GLONASS ENABLE

UPDATE TO ADD GLONASS TO NON-GLONASS GNSS RECEIVERS IN MATRIX PRO GS & AEROS CONSOLES

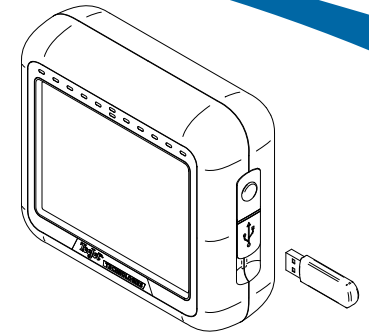
The GNSS antenna must be GLONASS capable. TeeJet's optional RXA-30 antenna is already GLONASS capable, but most Patch antennas sold with Matrix Pro GS consoles equipped with Receiver 6 GNSS receivers are GPS only, and will have to be replaced with GLONASS capable antennas in order to receive and apply GLONASS observations. Options include the RXA-30 antenna (part number 90-02720), and the GLONASS patch antenna (part number 78-50190).

GNSS PATCH

REPLACE WITH

GNSS GLONASS PATCH

OR

RXA-30
